**Charter Township of Comstock
Planning Commission Meeting**

**NOTICE AND AGENDA
December 15, 2016 at 7:00 PM
Lower Level of the Township Office**

STAFF REPORT

STAFF REPORT

<p>Sheet Title: SITE LAYOUT PLAN GULL RD RETAIL AVB</p> <p>Project: C-2</p> <p>Client:</p>	<p>Job No. 16-035D P.M.:TDH Drt: DJM QA/QC: 11/2/16</p> <p>ISSUED FOR/REVISIONS:</p>

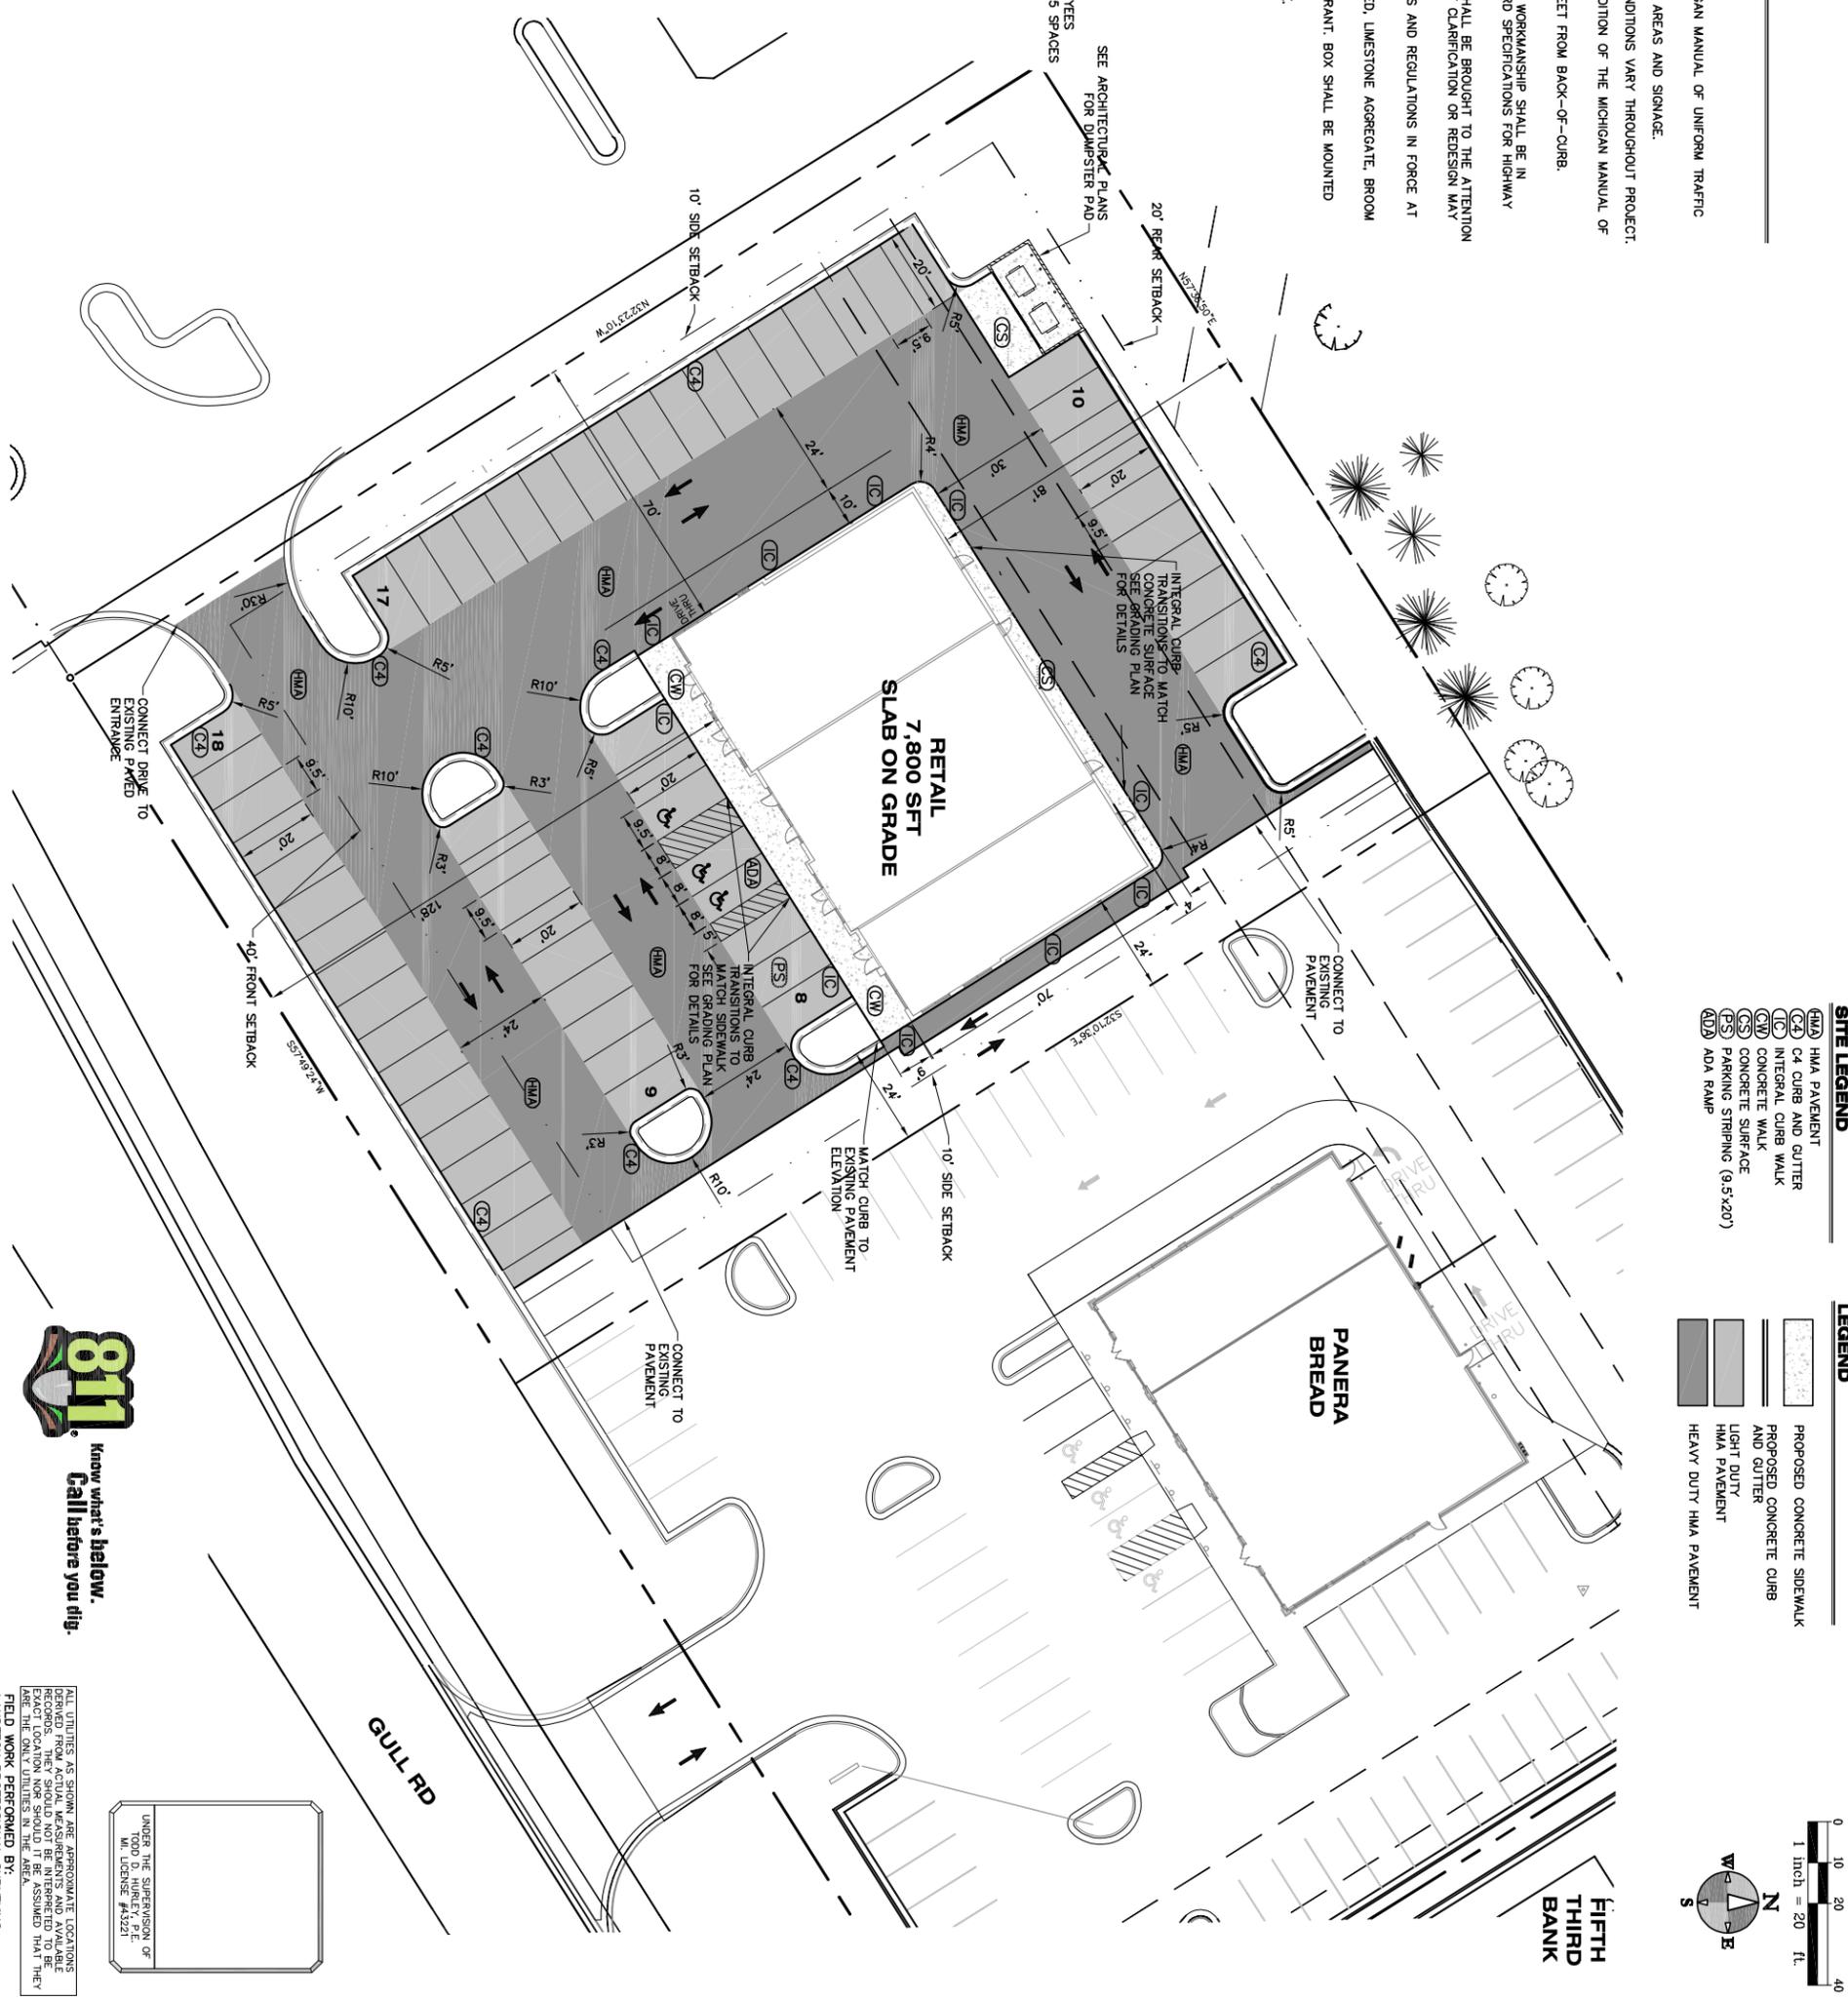
It is likely that loading/unloading will occur behind the building, however, it is not labeled.
* Applicant should speak to loading/unloading plans *

Sheet Title: **LANDSCAPE PLAN GULL RD RETAIL AVB**
 Project:
 Client:

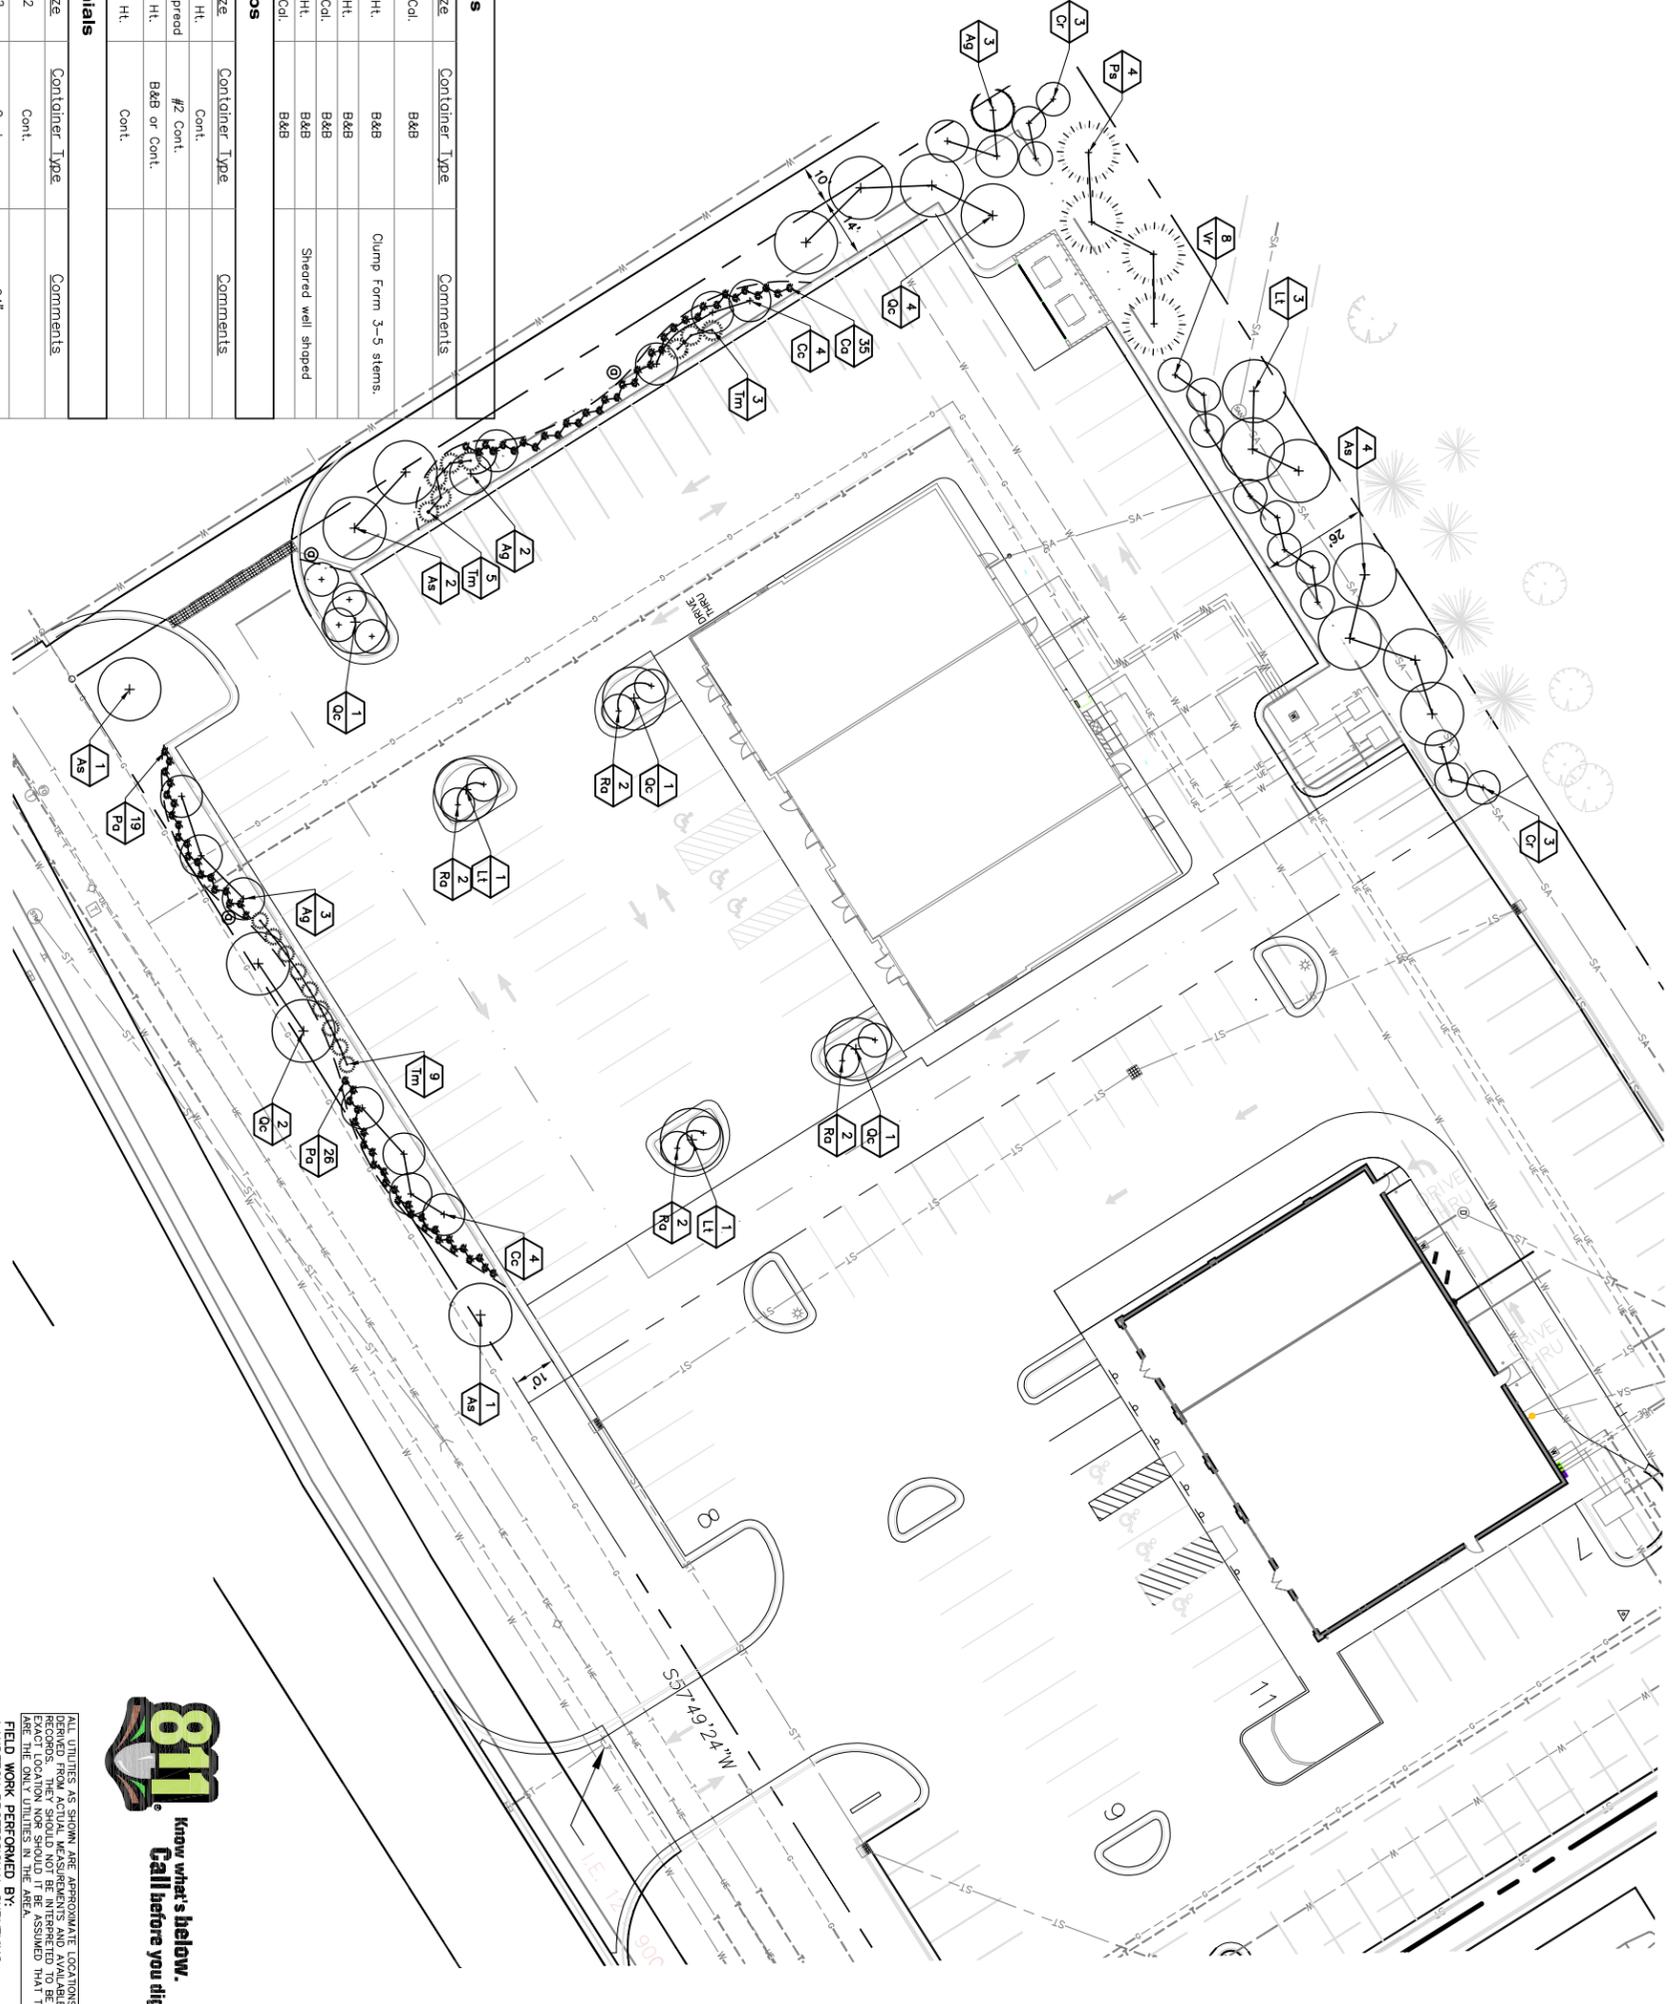
West – reduced greenspace width of 14 feet provided with plantings required in a Type C greenspace when all plants are labeled and missing understory tree that is labeled but not shown is provided. When adjacent parcel's greenspace is considered, the green strip will be 24 feet wide along the common property line.

North – abutting apartment development – Type D greenspace is required. Trees comply with the planting requirements but the required 26 shrubs are not shown.

Internal – Internal parking lot landscaping does not meet the required square footage and plants (1,550 square feet/minimum island area of 300 square feet/1 canopy tree and 2 low growing shrubs per 300 square feet).

1. Landscaping shall satisfy the requirements of the Zoning Ordinance as may be modified by the Planning Commission.
2. Exterior light fixtures for the building must be submitted for Township review and approval.
3. Site plan approval is subject to the approval of the Fire Department, pursuant to adopted codes.
4. Site plan approval is subject to the review and acceptance of the Township Engineer as adequate.
5. An Earth Change permit be obtained, if required by the Kalamazoo County Drain Commissioner, and a copy provided to the Township.
6. Hazardous Substance Reporting Form and Environmental Permits Checklist must be completed and submitted.

LIGHT FIXTURE SCHEDULE

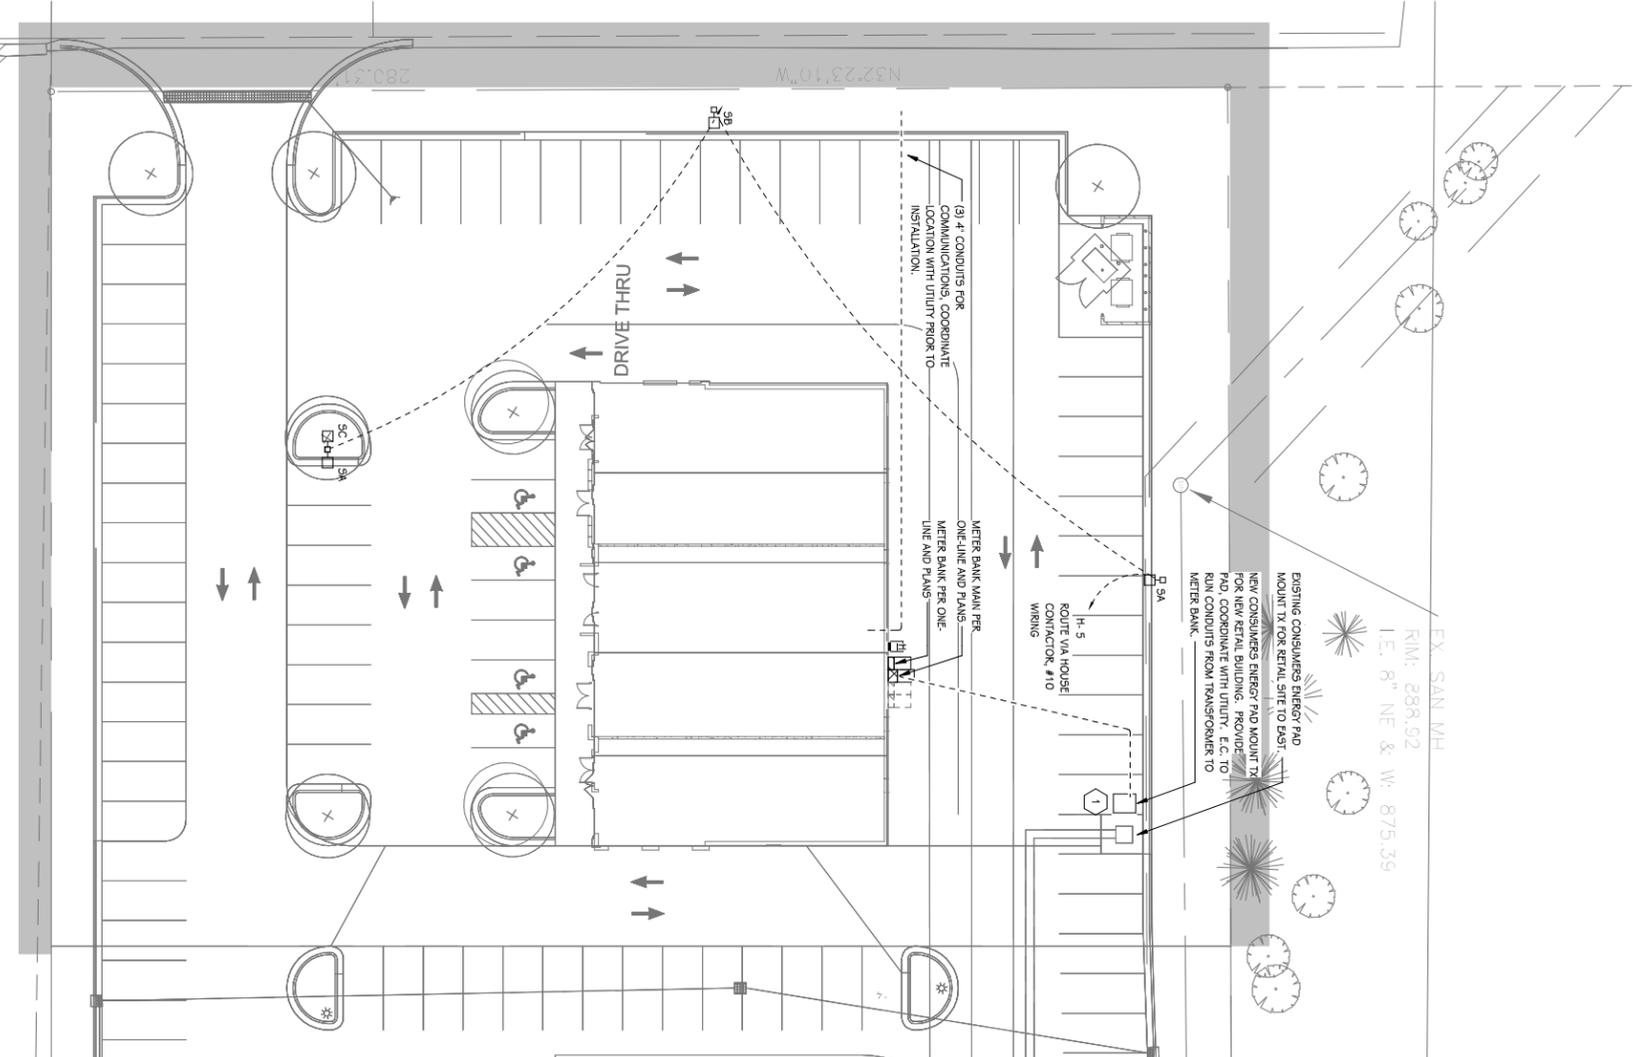
Lighting details have been submitted for the pole-mounted lights. No building-mounted lights have been shown on the site plan or fixture details submitted.
